## URGENT MEDICAL DEVICE CORRECTION

SUBJECT: P3700 Affinity® Three Birthing Beds distributed after October 2000 and equipped with the 12VAC Accessory Outlet option

# Subject: Affinity® Three Birthing Bed—Auxiliary Transformer Disabling Instructions

## **Location of Optional Outlet**

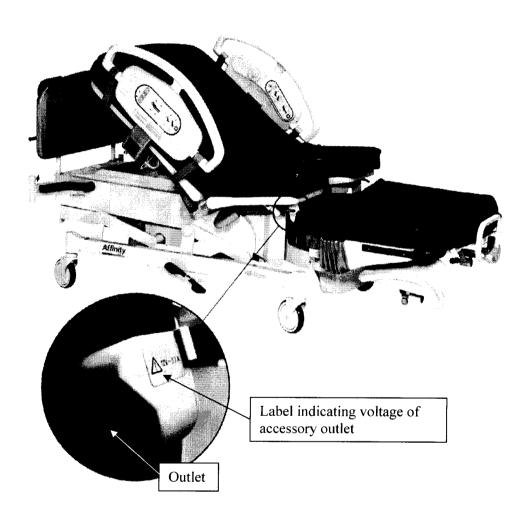
The affected units can easily be identified by viewing either the right or left side of the bed for the attachment of the optional 12VAC outlet. If your device has the outlet as indicated in the "Location of Optional Outlet," the Correction **must** be completed. If the outlets are not visible, then no transformer exists and no additional action is required for that bed.

Figure 1. Top Motor Cover Removal

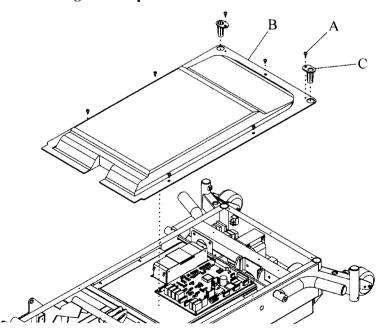
- 5. Unplug the bed from its power source, and engage the lockout control.
- 6. Remove seven screws (A) that secure the top motor cover (B) (see figure 1 on page 1).

- 7. Remove the two headboard bushings (C) from the top motor cover (B).
- 8. Remove the top motor cover (B) from the bed.
- 9. From the head end, locate the auxiliary and main transformers (see figure 2 on page 2).
- 10. Disconnect the small auxiliary transformer plug (two red wires) from the outlet connector (D) (red and black wire).
